Access Compliance Report

Public Rights-of-Way

Intersection ID: 18365	Main Street: TRYON_ST	Cross Street: TYVOLA_RD	Location: W
ADA ID: 3837F3FEE9C7	Ramp Type: BlendTrans2	Initial Pass/Fail: Pass	Overall Compliance: No
		Severity Score: 15

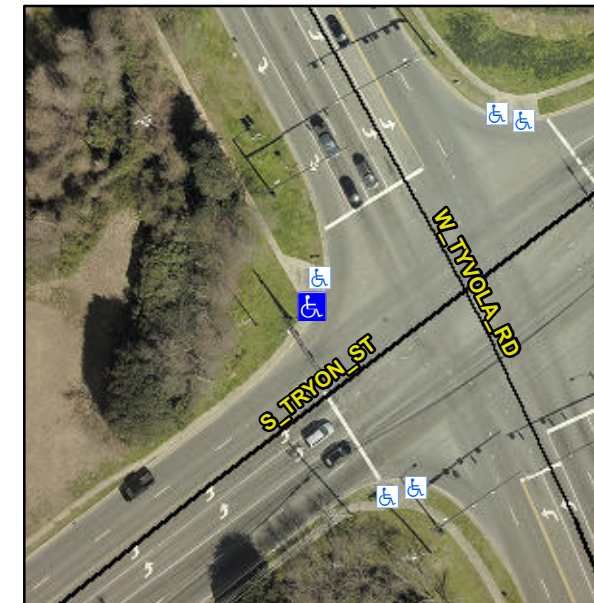
Not Found, R305.2, R302.7.2

N/A	Ramp inside XWalk1?	N/A	N/A	Ramp inside XWalk2?	N/A
	Road Slope (%)	0.4		Clear Space?	Yes
	Road X Slope (%)	2.6	N/A	Clear Space to XWalk (in)	N/A
Yes	Any Obstructions?	No	Yes	Storm Grate/Utility Hazard?	No
	Obstruction Type			Storm Grate/Utility Type	
		N/A			N/A
			Yes	Surface Condition? (G/P)	Good
			No	Curb Slope (%)	15.6

Remove & Replace Curb Ramp With Two New Directional Ramps or Equivalent.
